**DM/24/0407: New two-storey, three bedroom dwelling with vehicle parking.**

The latest plans have a large number of inaccuracies and contradictions. The height of the dwelling is one of the reasons for the resubmission. The elevation plan 'Proposed Elevations A1-202 rev A' has too many errors to be taken at face value.

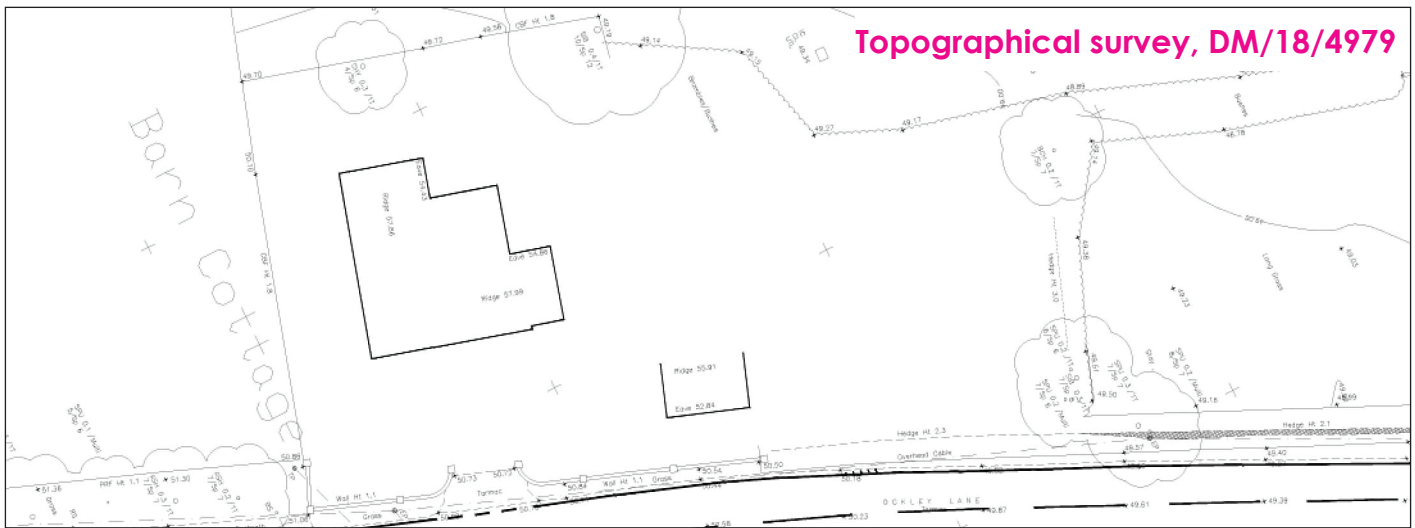
What was actually built is the opposite to what was approved. The dwelling is much higher and all the windows on the north elevation have been enlarged. The 'modest dwelling' has been 'super sized' and is as high as BC at the ridge, not including chimney. BC appears very much the subservient dwelling.

Grey slate roofing tiles have been used, contrary to the approved plan that has red tiles in the drawings. In addition, the existing garage appears to be retained by BC.

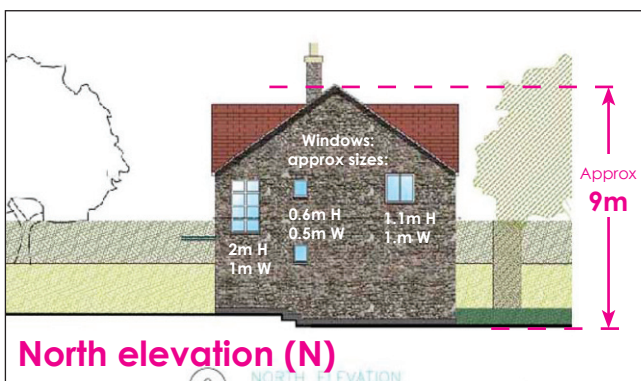
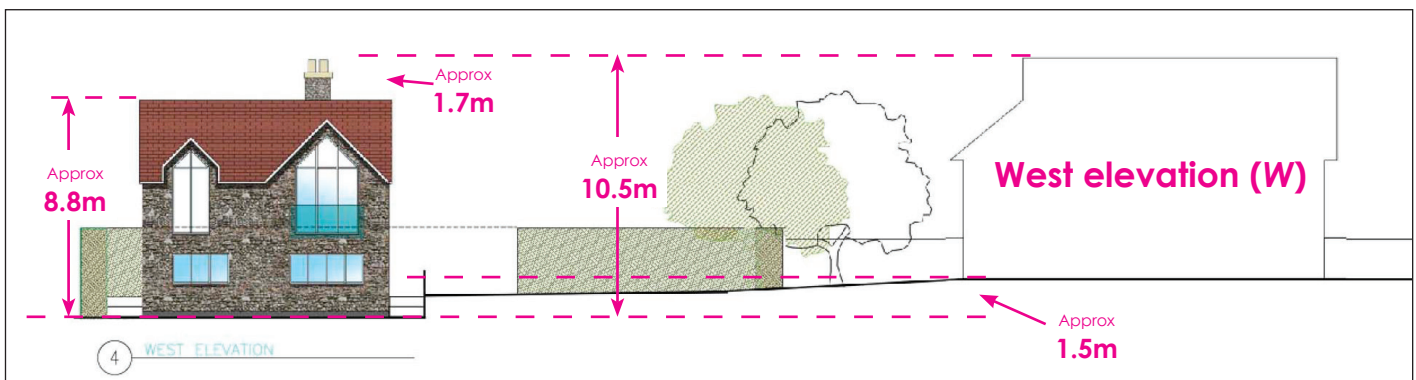
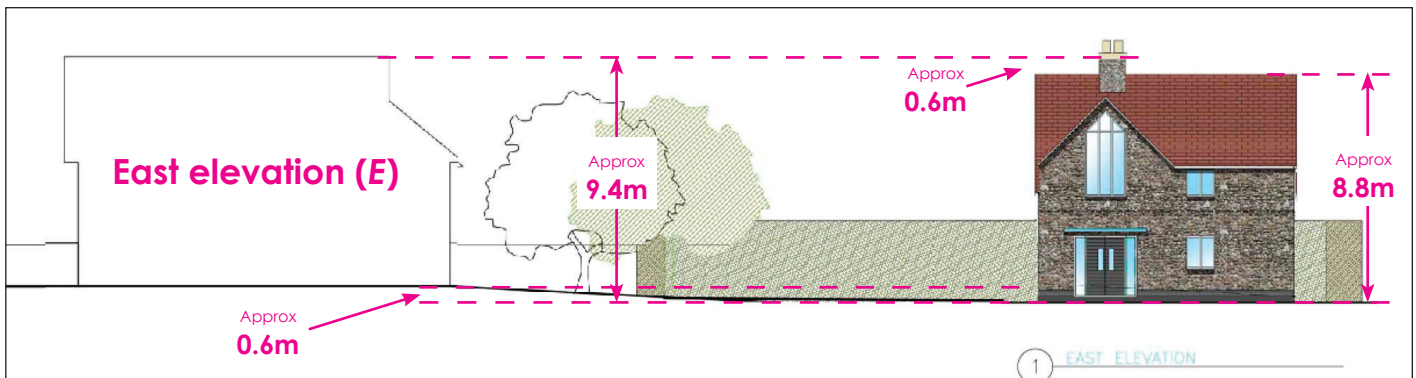
The dwelling is as high as BC and neither *E* or *W* elevations appear to be correct. Using BC ridge as a reference point; *E* elevation makes the dwelling at approx 9.4m high from 'ground level', and the *W* elevation shows the dwelling at 10.5m high from 'ground level'; yet the dwelling in both elevations is the same height of 8.8m.

Furthermore, on the *E* elevation, there is a difference of approx 0.6m between the ridge at BC and the dwelling; and there is approx 1.7m difference on the *W* elevation. Clearly the dwelling is not 1.7m below BC, something is not right.

The ridge line from both buildings remain static whichever angle they are viewed from, therefore, the discrepancy in height between *E* and *W* elevations makes no sense, and is misleading.

There is a raise in the foundation shown in the *N* elevation but the dwelling has the same height, approx 8.8m, on the *E* and *W* elevations.

YELLOW: Vehicle Turning Space DC-007, DM/24/0407  
 WHITE: Topographical survey, DM/18/4979  
 CYAN: Ordnance Survey plan, DM/18/4979

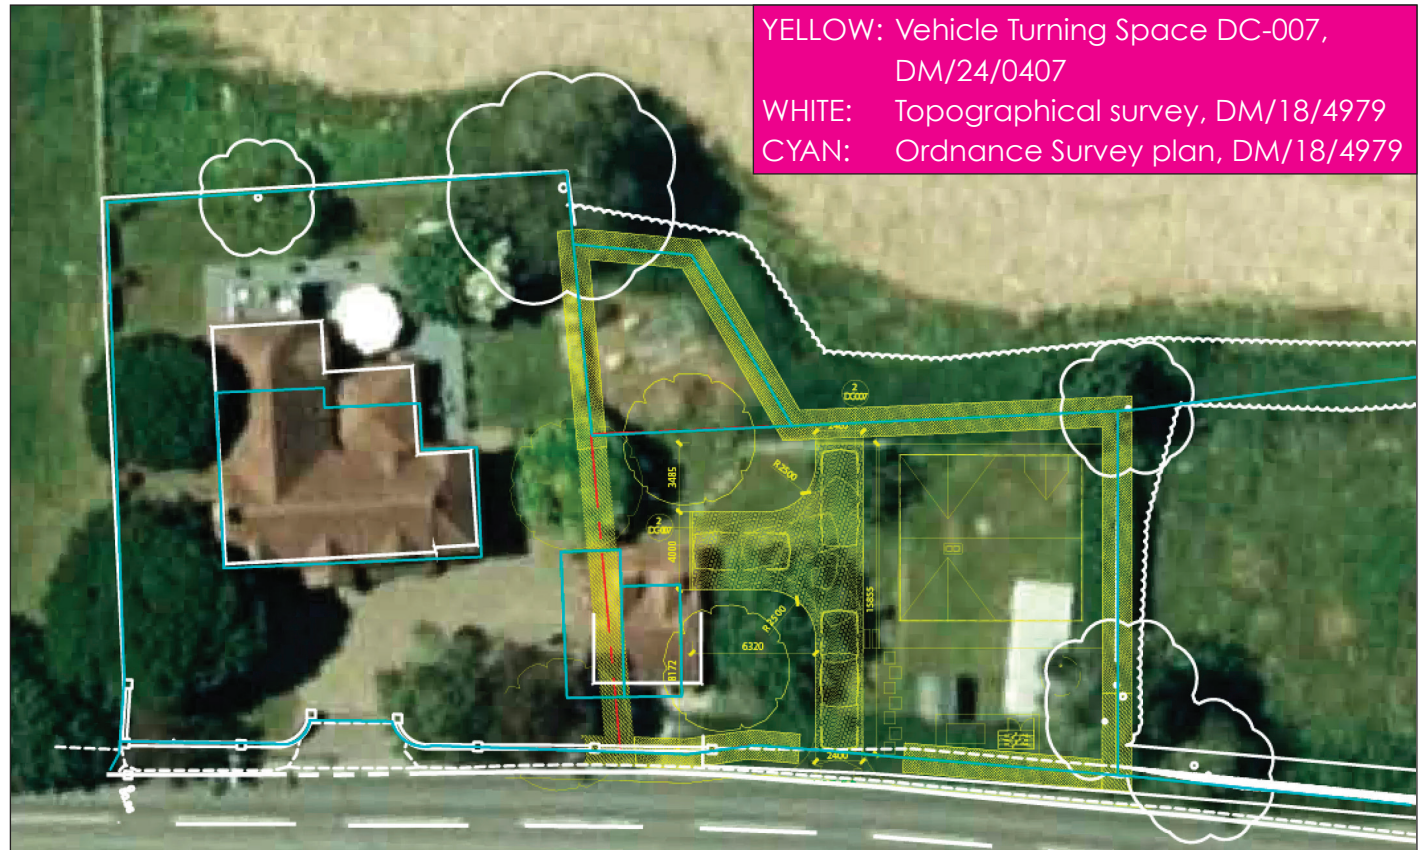
In the *N* elevation, the tallest side measures approx 9m from the ground, yet the same side is approx 8.8m on the *W* elevation, and does not reflect what is truly happening on the ground.

The aerial image above is combined with OS and topo plan. The OS plan shows the location of the old garage and is used throughout the resubmission, such as the plan below, and is incorrect. However, the topo plan concurs exactly with the existing garage on the ground, and cuts across the turning head.

Existing Landscape Plan, Site Section and Street Elevation  
 Site Near Barn Cottage

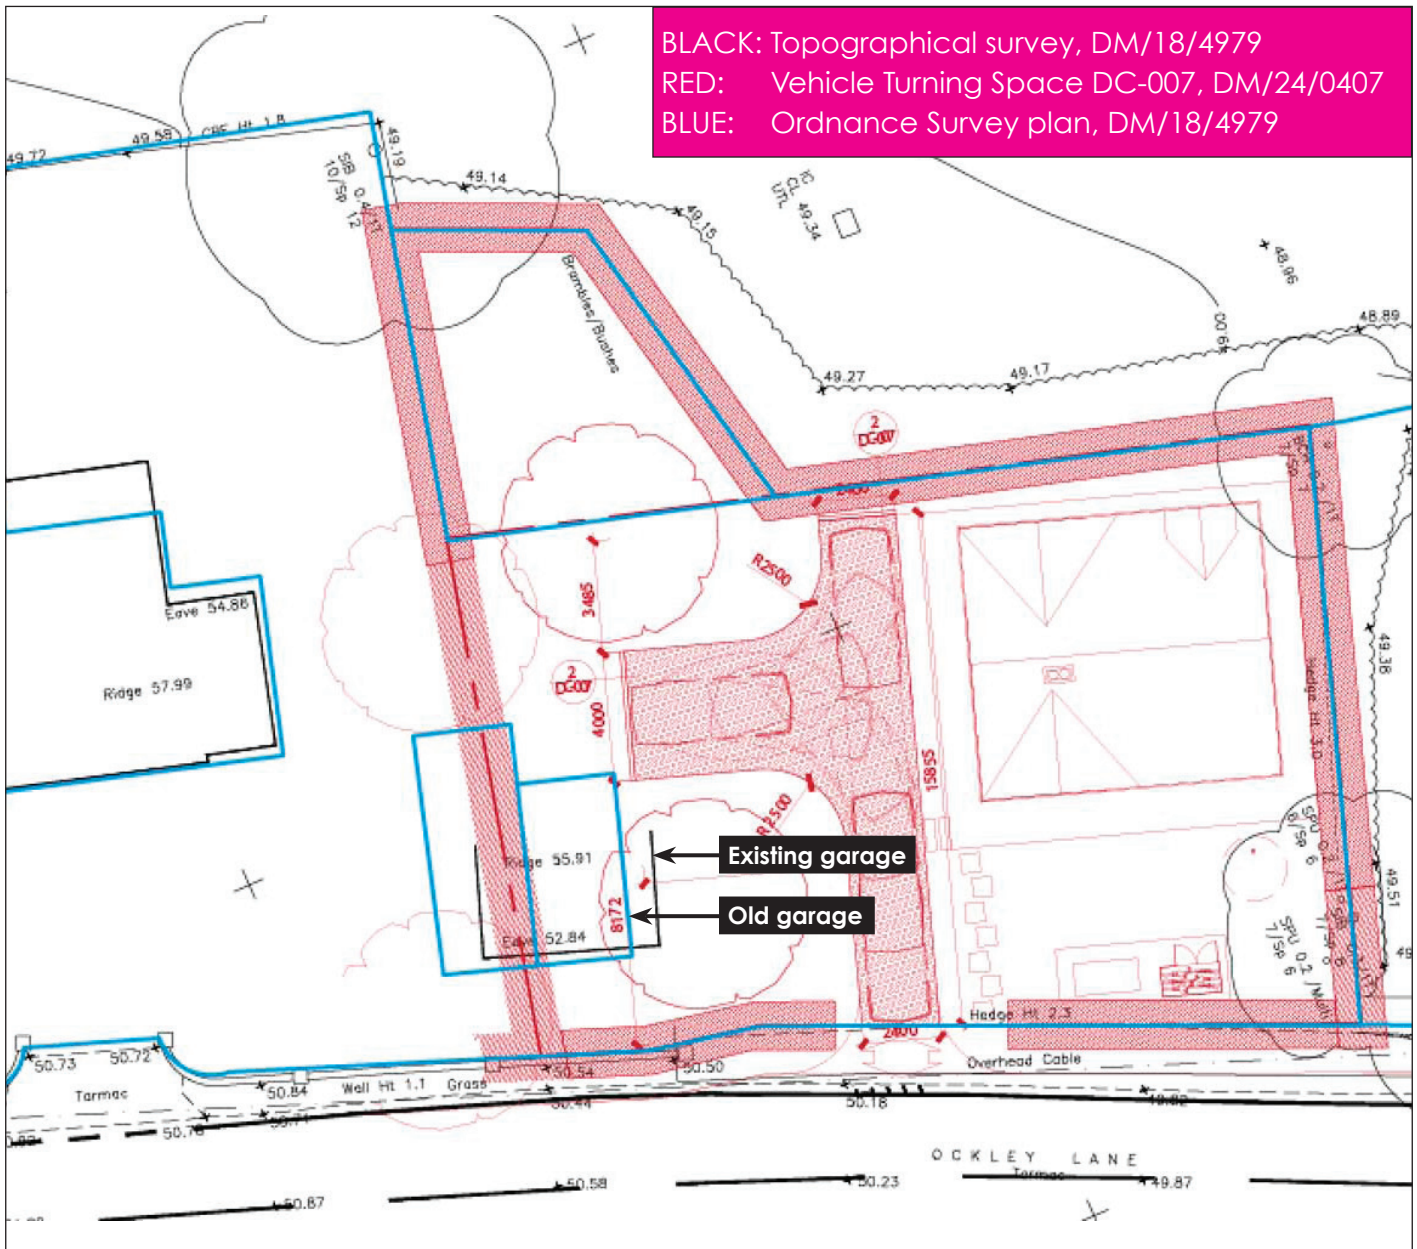
RED: Topographical survey DM/18/4979:  
 The existing garage on the Landscape plan does not register with the topo survey.

In our opinion, the existing garage is located further north than the resubmission suggests, as shown in the diagram above.
